**Gravity Probe B Relativity Mission**

**Probe-C Assembly/SMD Integration (& Test) Readiness Review Completion Certificate**

**GP-B P0483**

**May 11, 1999**

Fig. 1 TEST FLOW CHART  
FOR  
AIRLOCK/DEWAR INTEGRATION - GP-B P0134

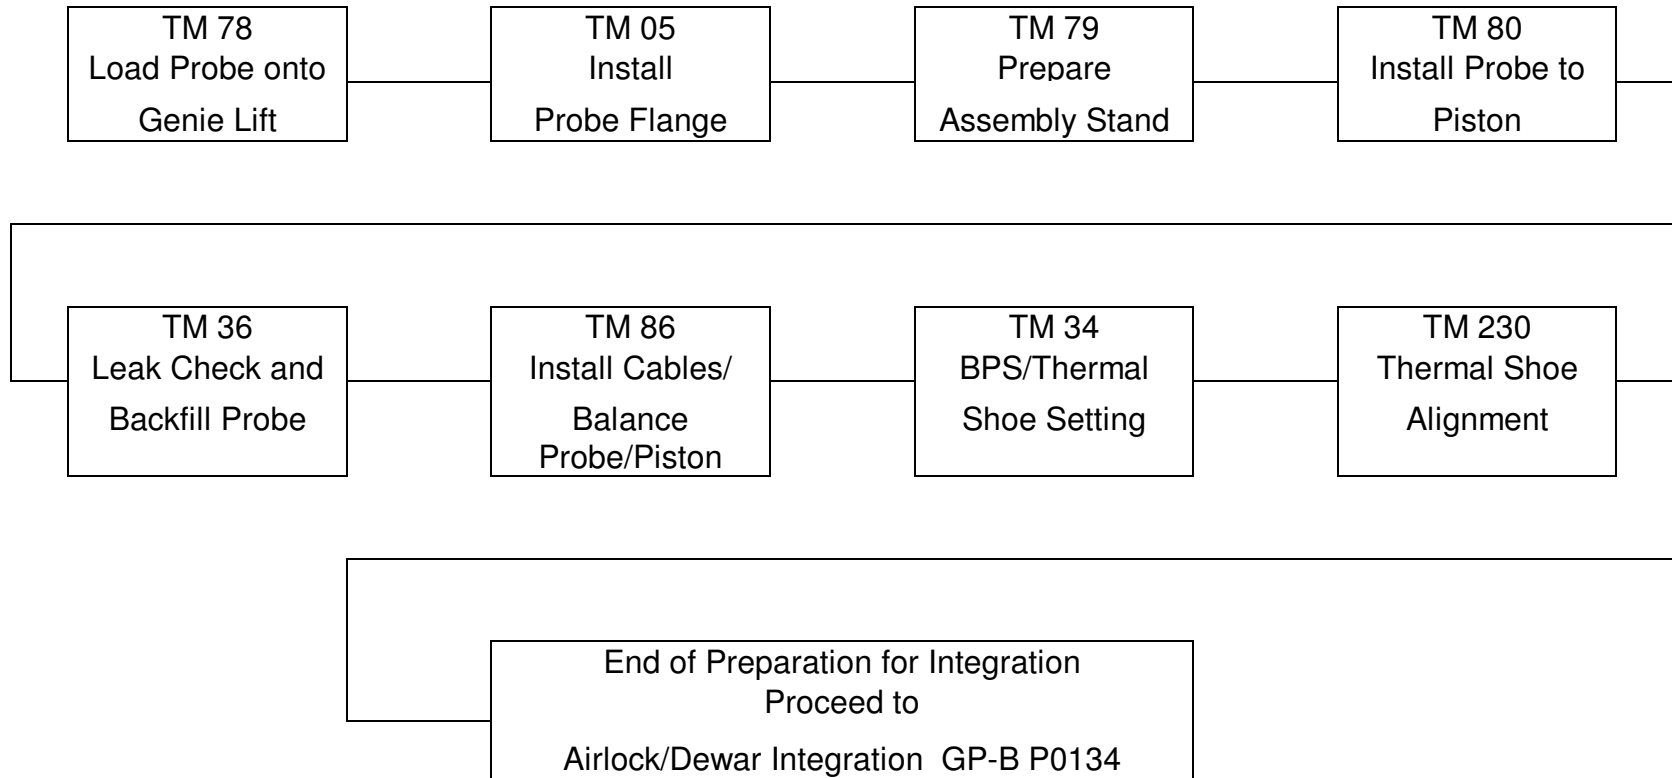
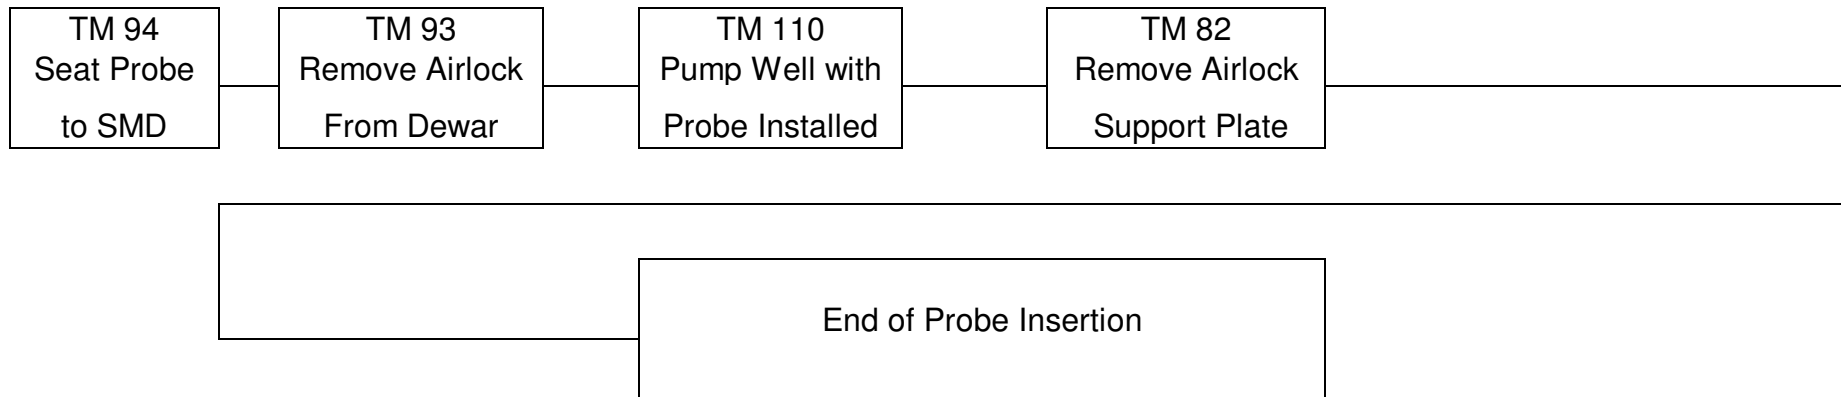
7) Perform visual inspection of all lifting hardware.	J. Janicki	5/14/99	Closed
8) Update the Test Flow Chart by removing TM93.	M.R. Anderson	5/14/99	Closed
